EGR Temperature Sensor Routing
VAH, VHD, VN
D13H

FSB 293-022, EGR Temperature Sensor Routing

(August 2013)

W2083701

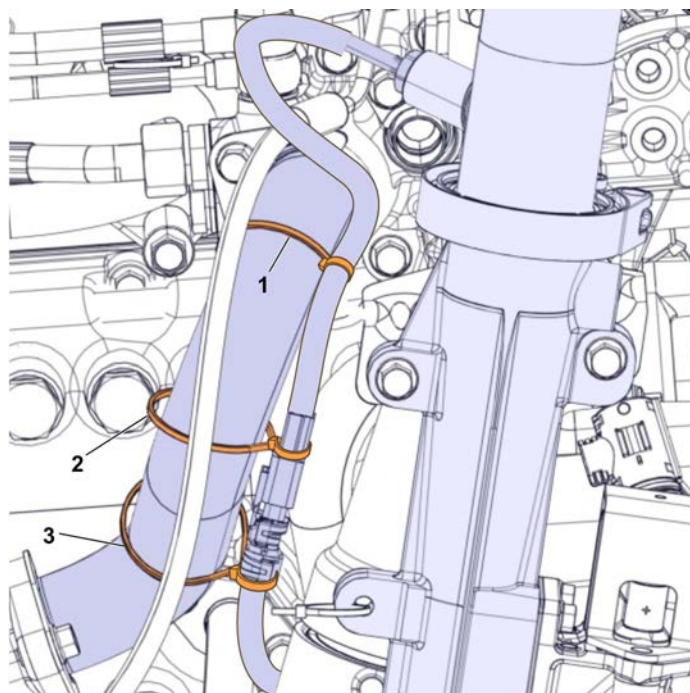
In the event that an EGR temperature sensor replacement is required on a VOLVO D13H engine, a new routing configuration is required. The new configuration requires three double loop cable ties (part number 8079360) to secure the new EGR temperature sensor connector directly to the coolant pipe. On previous installations, the venturi pipe was a mounting point and only two ties were required.

- 1 Tie attaches 76 mm (3 in) above the back shell on the temperature sensor harness.
- 2 Tie attaches between the back shell and the temperature sensor connector.
- 3 Tie attaches directly below the back shell on the engine harness side.
